Access Compliance Report

Public Rights-of-Way

(Curb Ramps)

| Intersection ID: 24385 | Main Street: BEVERLY_CREST_BV | Cross Street: BECKMORE_PL | Location: NW |

| ADA ID: 433A58026269 | Ramp Type: Combination1Diag | Initial Pass/Fail: Fail | Overall Compliance: No |

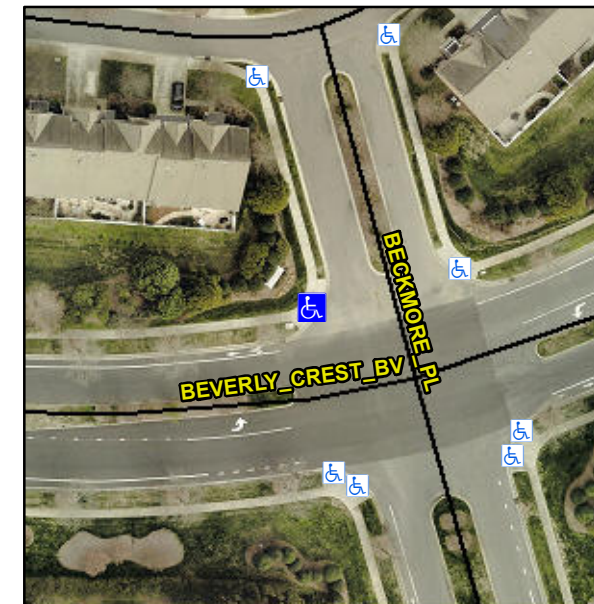
RP & RT RP < 5%

Not Found, R304.3.2, R304.5.3

| Compliance | Description | Data | Compliance | Description | Data |
|------------|--------------------------|------|------------|-----------------------------|------|
| No | Ramp Slope LT (%) | 8.5 | Yes | Ramp Slope RT (%) | 0.3 |
| No | Ramp XSlope LT (%) | 5.2 | No | Ramp XSlope RT (%) | 3.9 |

Remove & Replace Curb Ramp With Two New Directional Ramps or Equivalent. Remove & Replace Sidewalk.
